Airworthiness Directives; Sikorsky Aircraft Corporation (Sikorsky) Model S-92A Helicopters

ACTION: Notice of proposed rulemaking (NPRM).

Sikorsky Aircraft Corporation: Docket No. FAA–2011–1115; Directorate Identifier 2010–SW–011–AD.

Figure 1. Cat 'A' Takeoff and Landing Gross Weight

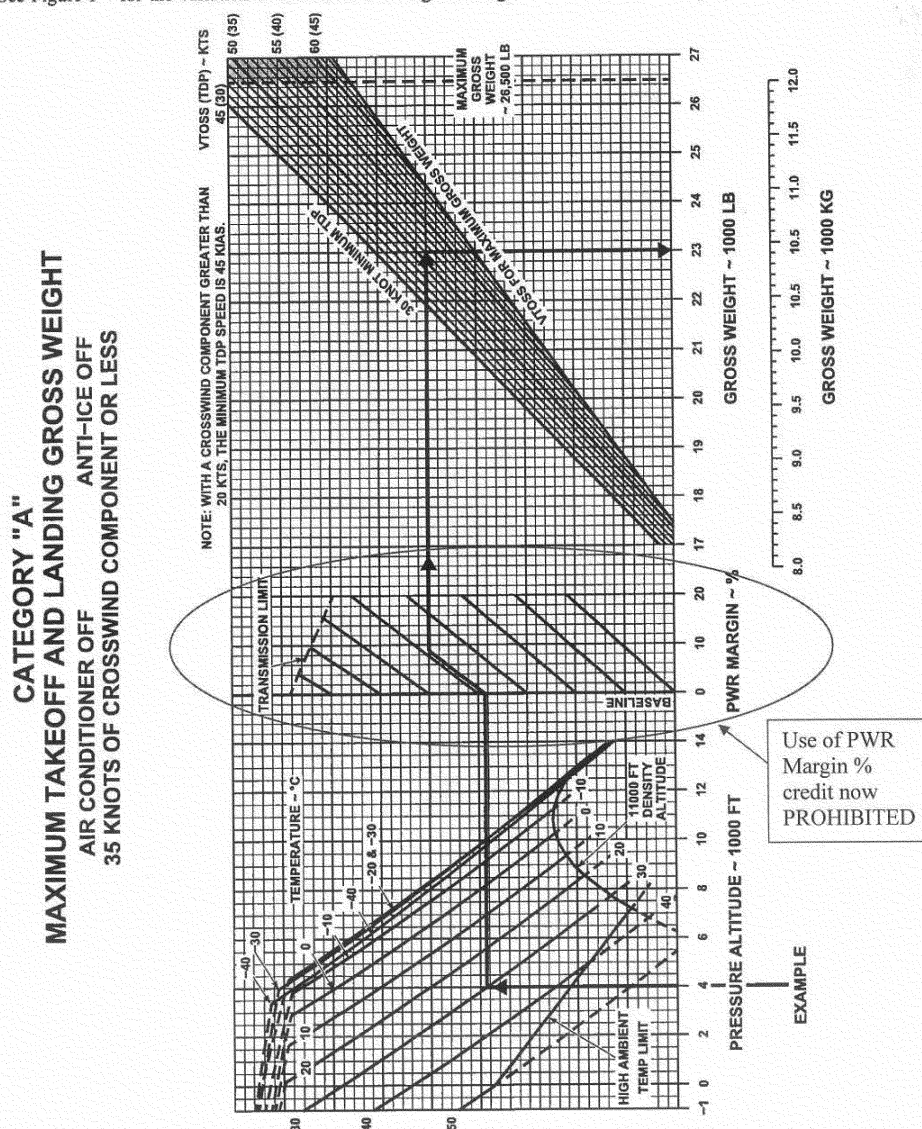
(b) If the RFM already contains the revisions appropriate for your helicopter as listed in the following Table 1, all dated April 9, 2008, with the correct performance charts, without the performance credit as depicted in the circled area of Figure 1 of this AD, the operating limitation required by paragraph (a) of this AD does not need to be inserted into the RFM.

Note 1: Previous RFM revisions allowed for the use of above-specification engine power margin as depicted in the circled area of Figure 1 of this AD.

(a) By making pen and ink changes, insert into the Operating Limitations section, Part 1, Section 1, *Weight Limits*, of RFM SA S92A–RFM–002, –003, –004, –005, and –006 the following limitation “Performance credit for above specification engine power margin is prohibited.”
